Access Compliance Report

Public Rights-of-Way

Intersection ID: 13959	Main Street: CLEVELAND_AV	Cross Street: E_PARK_AV	Location: N
ADA ID: 737A7413BF90	Ramp Type: BlendTrans1	Initial Pass/Fail: Fail	Overall Compliance: No
Severity Score: 12.5			
Codes/Mitigation Info/Possible Solution		Field Measurements/Component Compliance

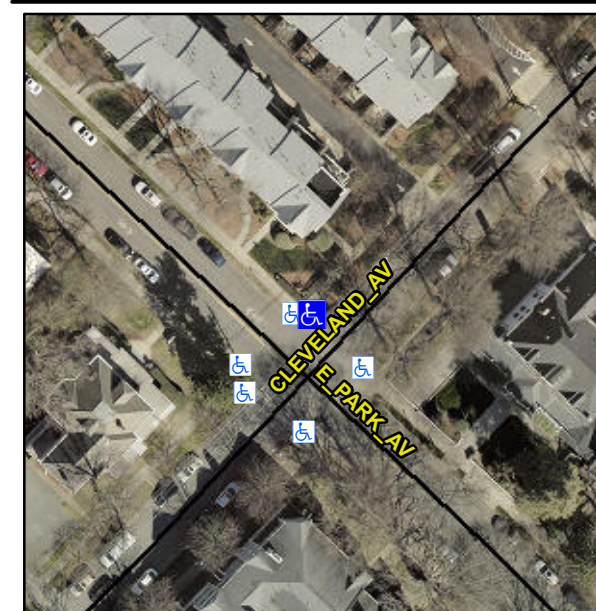
NO CURB LINE

R304.5.3

Compliance	Description	Data	Compliance	Description	Data
N/A	Ramp Length (in)	31.0	Yes	BlendTrans Slope (%)	3.2
Yes	Ramp Width (in)	48.0	No	BlendTrans XSlope (%)	5.1
N/A	Flare Type LT	N/A	N/A	Flare Type RT	N/A
N/A	Flare Slope LT (%)	N/A	N/A	Flare Slope RT (%)	N/A
N/A	Flare Traversable LT?	N/A	N/A	Flare Traversable RT?	N/A
N/A	Landing Length (in)	N/A	N/A	DWS Provided?	N/A
N/A	Landing Width (in)	N/A	N/A	DWS Contrast?	N/A
N/A	Landing Slope (%)	N/A	N/A	DWS Length (in)	N/A
N/A	Landing X Slope (%)	N/A	N/A	DWS Full Width?	N/A
N/A	Landing Curb? (Y/N)	N/A	N/A	DWS Offset (in)	N/A
N/A	Shared Landing?	N/A			
N/A	Gutter Ponding?	N/A	N/A	Gutter Slope (%)	N/A
N/A	Gutter Lip Ht (in)	N/A	N/A	Gutter X Slope (%)	N/A
N/A	Painted X Walk1?	No	N/A	Painted X Walk2?	N/A
	X Walk 1 Direction	To SE		X Walk 2 Direction	N/A
	X Walk 1 Width (in)	N/A		X Walk 2 Width (in)	N/A
	X Walk 1 Slope (%)	3.3		X Walk 2 Slope (%)	N/A
	X Walk 1 X Slope (%)	4.3		X Walk 2 X Slope (%)	N/A

Remove & Replace Curb Ramp With Two New Directional Ramps or Equivalent.
